Whitten Architects  
37 Silver Street Portland, Me 04101

REVISION TO EAST WALL 4.29.2014  
13 ST. LAWRENCE STREET  
LAWRENCE WHITTEN LLC • G.P. WHITTEN ARCHITECT • PORTLAND

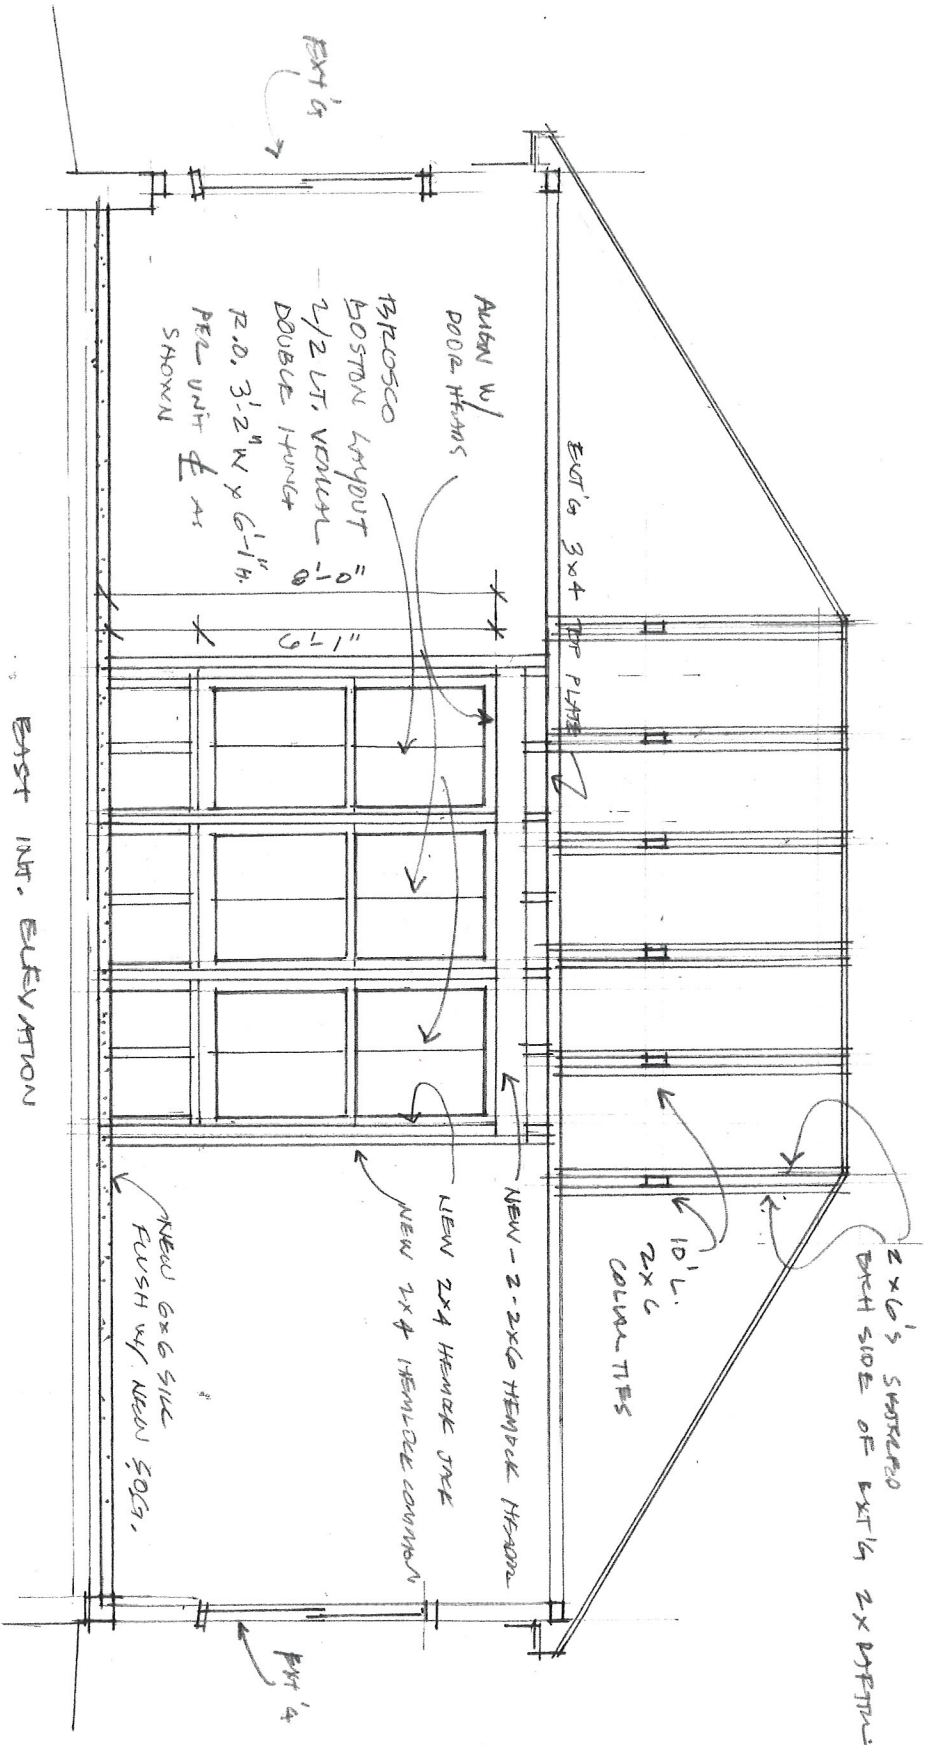
3 UNITS →
